Office Action Summary

10/561,893

DETAILED ACTION

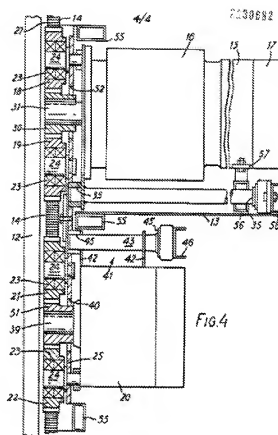
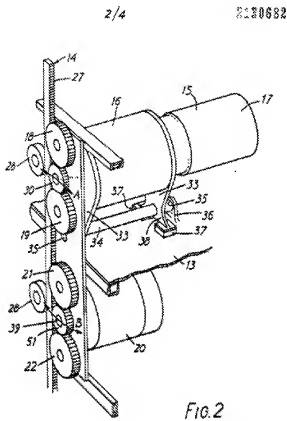
9. As to claim 1, Martin '682 discloses a drive assembly for a preferably vertically movable carriage (mounting plate 25, page 2, line 95), a correspondingly disposed stationary rack (14) of which the associated pinion (30) is operable for vertically moving carriage (mounting plate 25) through a transmission (gearbox 16) by means of a drive motor (15) having a static current actuated brake (electromechanical brake 17) at the end of the B-end bearing plate (flange or brackets 33), with additional carriage retaining means provided and engageable as needed to secure the vertically movable carriage in place, characterized by said retaining means comprising an additional brake unit (overspeed safety brake 20, page 2, line 11) disposed on a carriage

(mounting plate 25) and adapted to cause a pinion (51) of its own to directly engage rack (14), with pinion (51) idling along with the normal movements of carriage (mounting plate 25), and with brake unit (safety brake 20) adapted to be actuated independently from static-current brake (electromechanical brake 17, page 2, line 78).

FIG. 1

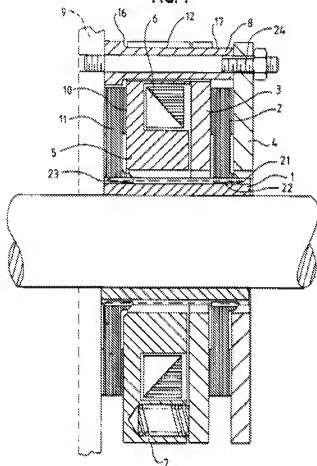
23. Claim 10 is rejected under 35 U.S.C. 103(a) as being unpatentable over Martin '692. Martin '692 discloses the claimed invention except for the two parallel flats (17), machined away for reducing its structural height, i.e. the distance thereof to drive motor(2) on carriage (13). It would have been obvious to one having ordinary skill in the art at the time the invention was made to machine away the two parallel flats, since it has been held that omission of an element and its function in a combination where the remaining elements perform the same functions as before involves only routine skill in the art. *In re Karlson*,
